2020 Corvette: Service Bulletin: #N202302840: Service Update - Door Paint Chipping

Subject: N202302840 — Door
Paint Chipping
Models: 2020 Chevrolet Corvette

Release Date: April 2020

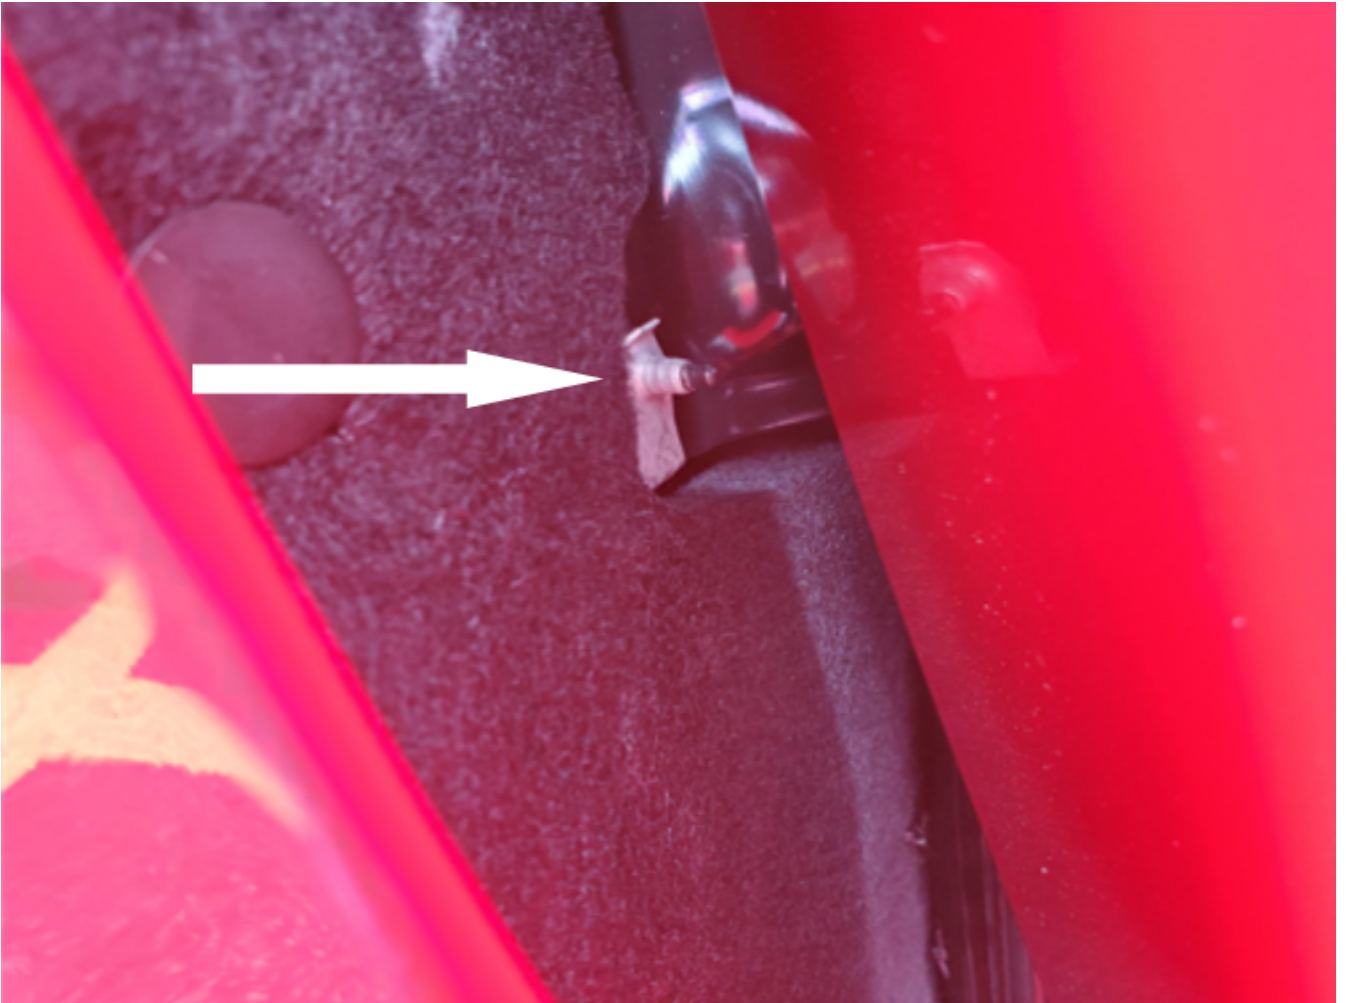
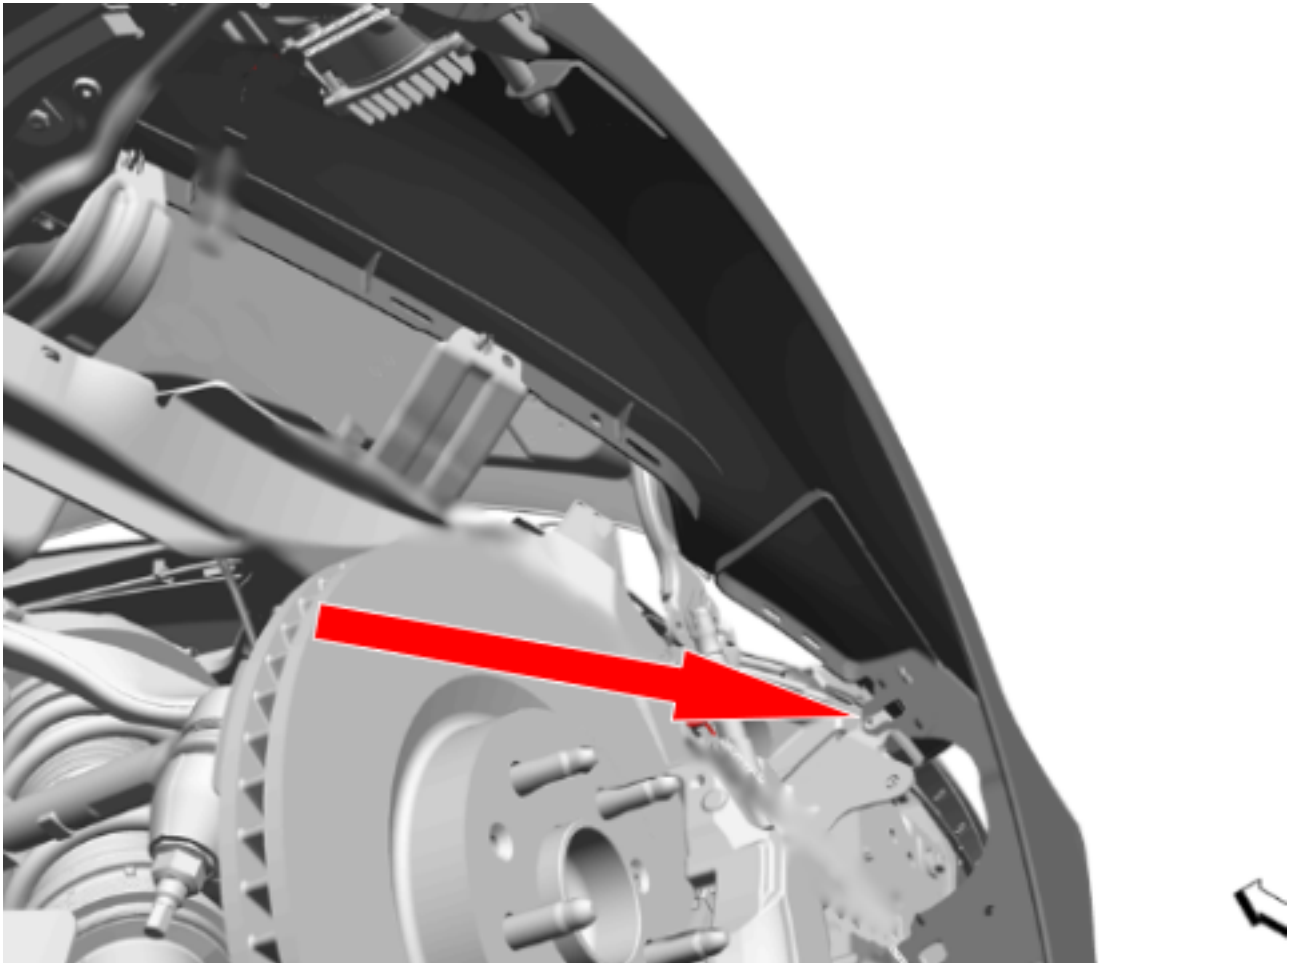
1. Carefully open the left front door inspecting for any contact with the fender fastener. This fastener is located just below the door check strap area.
2. Locate the threaded portion of the fender mounting bolt where

it exits the nut.

3. Count the number of threads showing.

- If less than 1 full thread is showing, no further action is required.

- If more than 2 threads are showing, proceed to step # 4.
 - Partially remove the wheelhouse liner to access the rear fender mounting fasteners. Refer to *Front Wheelhouse Liner Replacement* in SI.
1. Locate and remove the center fender to body fastener as shown.
 2. Install the shorter service fastener. Tighten 9 Nm (80 lb in).
 3. Reinstall the wheelhouse liner. Refer to *Front Wheelhouse Liner Replacement* in SI.
 4. Repeat steps 1-7 on the right side of the vehicle.
